Blythe Energy LLC
700 Universe Blvd.
Juno Beach, FL 33408

RE: CEC-99-AFC-8C Blythe Energy Project Transmission Line

August 25, 2008
Data Response
Blythe Energy Project Transmission Line
Insignificant Project Change Request

Figure 2-2
Re-alignment of Structures
153-159, 221-223, 232-234, 343-345

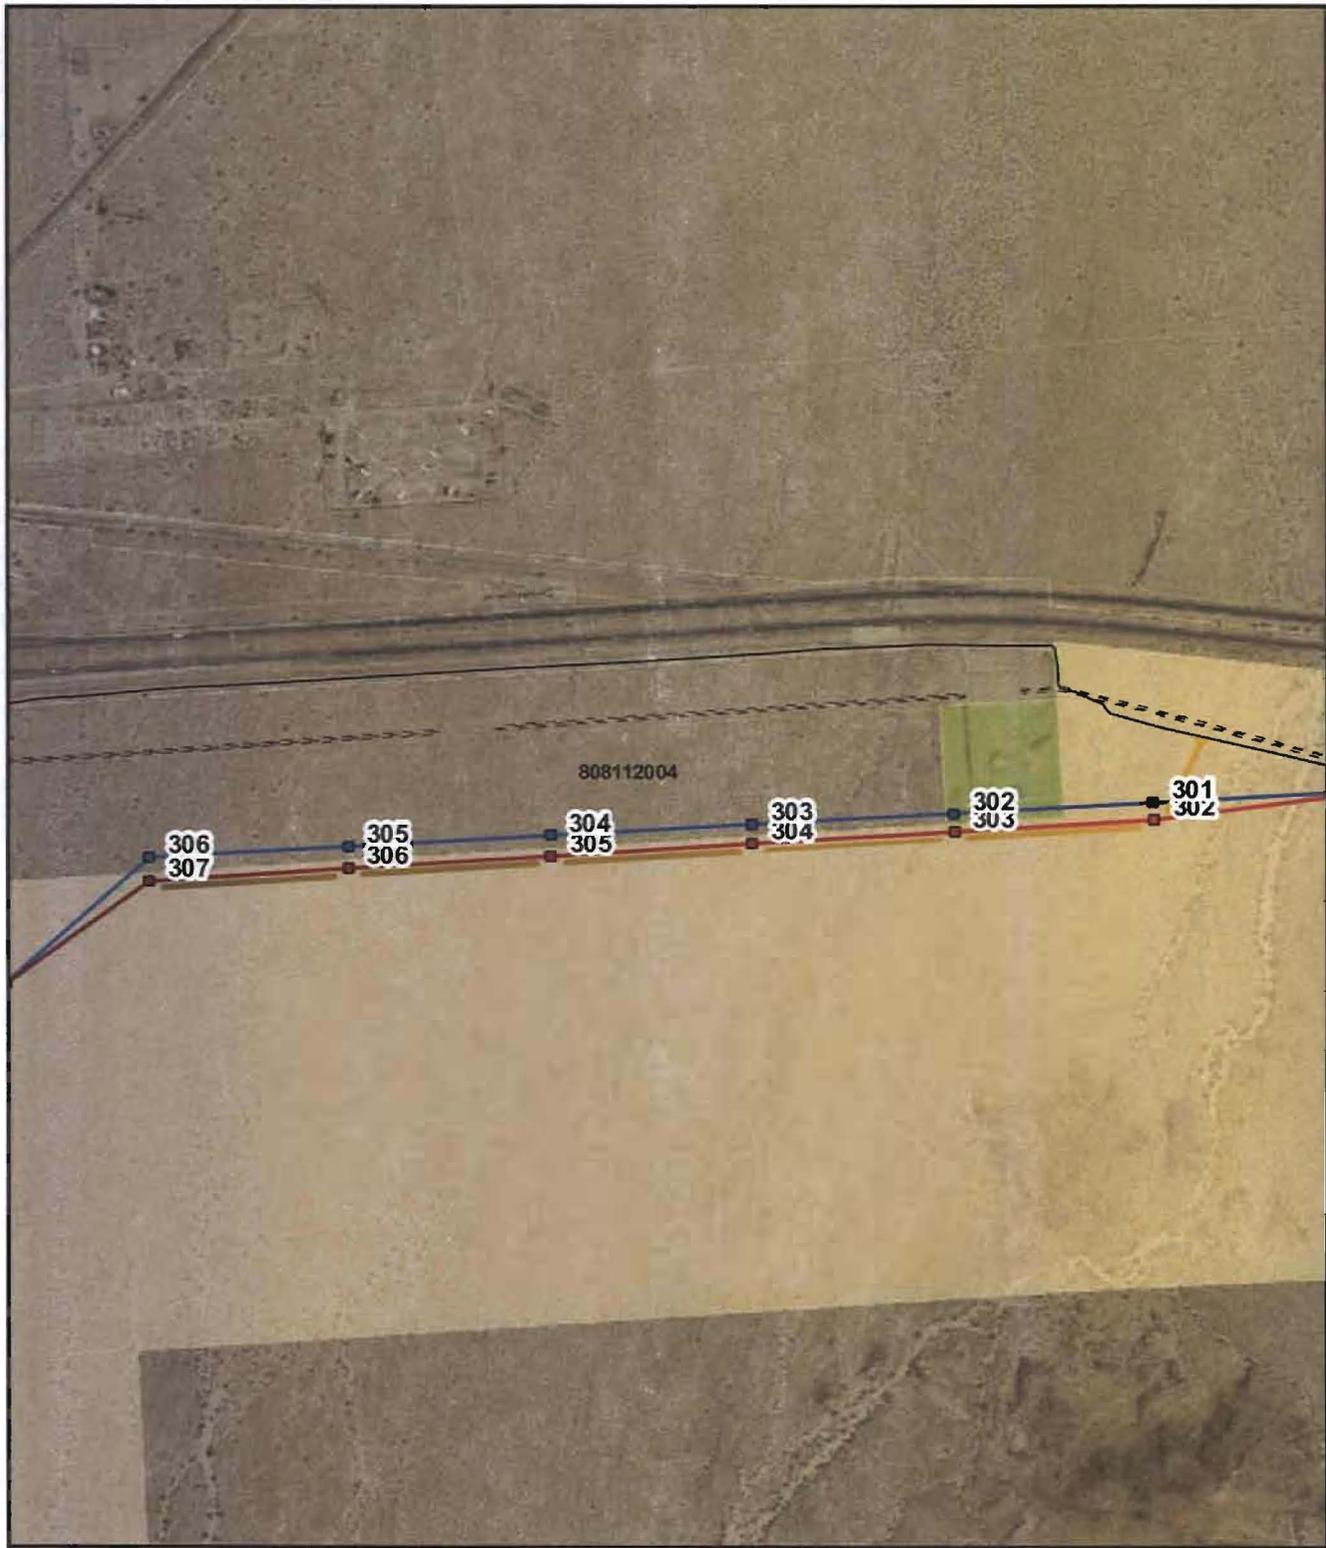
The proposed locations of the pole structures in the original T-line alignments. The numbered locations along the original T-line alignment should be added to the aerial photograph figures shown in the July 2008 document. These points are needed to compare habitat being affected by the proposed T-line re-alignment at the structure locations; and
A recalculation of disturbance acreages (i.e., Table 3 on page 4.3-25 of the Revised Staff Assessment/Draft Environmental Assessment) for additional structures and length in the proposed T-line re-alignment. Though additional disturbance acreages were calculated for the changes in the laydown areas and the access/spur roads, the additional structures and any length changes resulting from the re-alignment were not included. Any differences from original impact acreages may affect the required payments for habitat compensation, which are included in conditions of certification.

We have attached the requested revised Figures 2-2 through 2-7 that show the relationship between originally estimated pole locations and requested revisions.

The proposed Insignificant Project Changes have a different impact on disturbance than the originally proposed alignment and laydown yards, but the difference is very small and is easily taken care of using the empirical calculation methods specified in Conditions of Certification BIO-16 and BIO-17. When disturbance was estimated by both Blythe Energy and the Commission Staff in 2005, it was done based on an estimated average disturbance per structure and per road. Although we could produce a different calculation now that we know more precisely the number and type of structures, it would not make a material contribution to understanding of or mitigation of environmental impact. For example, the installation of the concrete-steel hybrid and the all-steel structures will require a smaller crane with a smaller footprint than that needed for all-concrete poles. Roads to accommodate the concrete-steel or all-steel structures do not need to have wide turning radii to accommodate the full pole length. We would expect smaller disturbance in those cases. In addition to the probable reduction in disturbance caused by structure type changes, we would expect additional disturbance where structures have been added and a slight increase in disturbance for H-frame structures.
